Contract No. T200811301
Federal Aid Project NH-2015 (20)
US 301, MARYLAND STATE LINE TO LEVELS ROAD
New Castle County

Enclosed is Addendum No. 1 for the referenced contract consisting of the following:

CONTRACT T200811301.01

US 301, MARYLAND STATE LINE TO LEVELS ROAD

GUIDE SIGN STEEL SUPPORT CHART

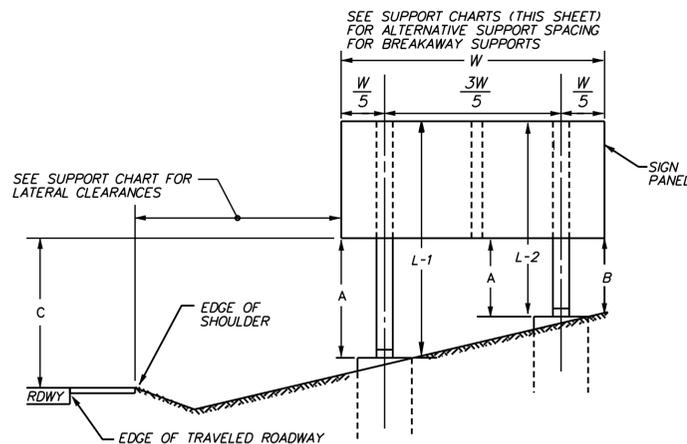
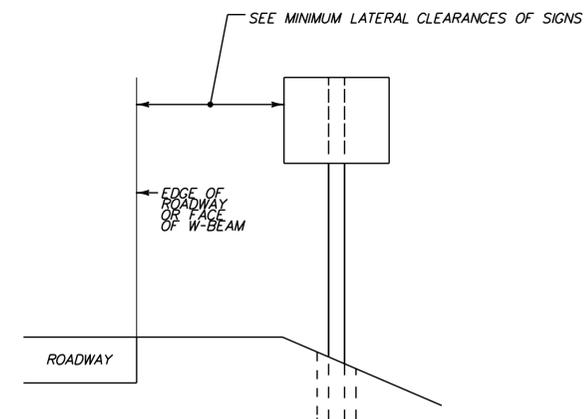
7. Two (2) pages, Plan Sheets 474 & 788, revised, to be substituted for the same pages in the Proposal.
8. Eight (8) pages, Environmental Requirements Statement, revised, no longer stipulated, to be substituted for the same pages in the Proposal.
